Part 5 Application **ACCESS REPORT**

Reference Number: 21316

Collard Maxwell Architects

289-293 Beauchamp Rd,
Matraville, NSW

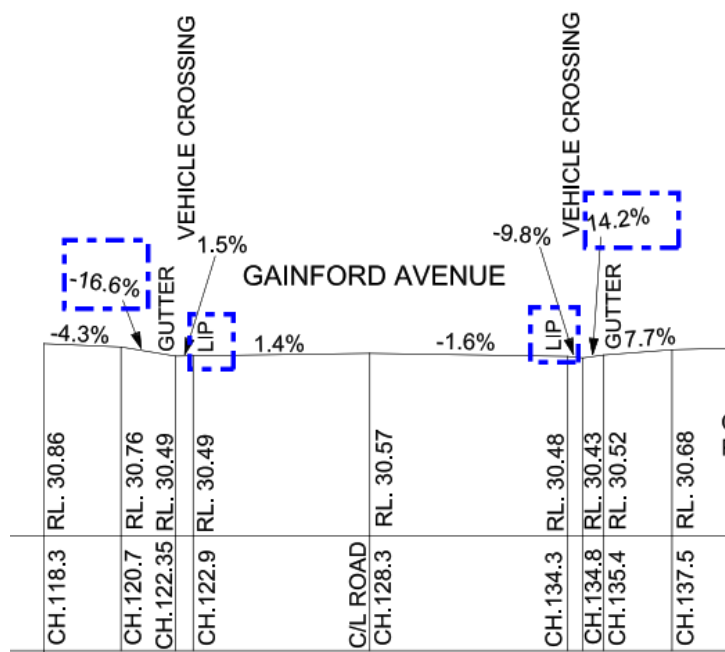
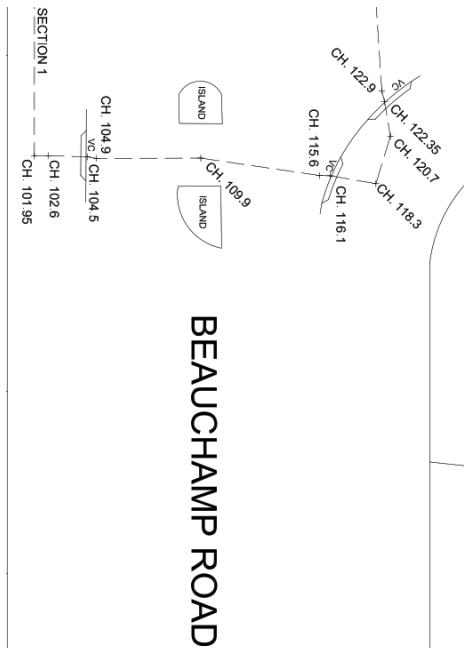
-13.7% = 1:7.30

Survey notes "LIP" on both sides of the crossing at Beauchamp Road. The crossing needs to be via an AS1428.1 compliant kerb ramp on both sides of Beauchamp Road. This is required for compliance.

A section of -13.7% is provided which is 1:7.30. SEPP requires a maximum grade of 1:8. This area appears to be associated within a non-compliant kerb and provision of an AS1428.1 compliant kerb ramp will resolve the non-compliance.

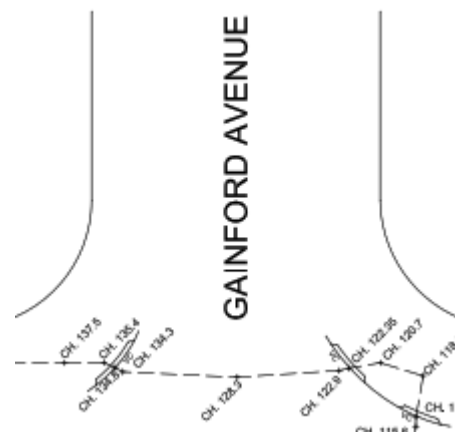
16.6% = 1:6.02 14.2% = 1:7.04

Survey notes "LIP" on both sides of the crossing at Gainford Avenue. The crossing needs to be via an AS1428.1 compliant kerb ramp on both sides of Gainford Avenue. This is required for compliance.

A section of -16.6% is provided which is 1:6.02 and a section of 14.2% is provided which is 1:7.04. SEPP requires a maximum grade of 1:8. Both of these areas appear to be associated with non-compliant kerbs and provision of AS1428.1 compliant kerb ramps will resolve the non-compliance.
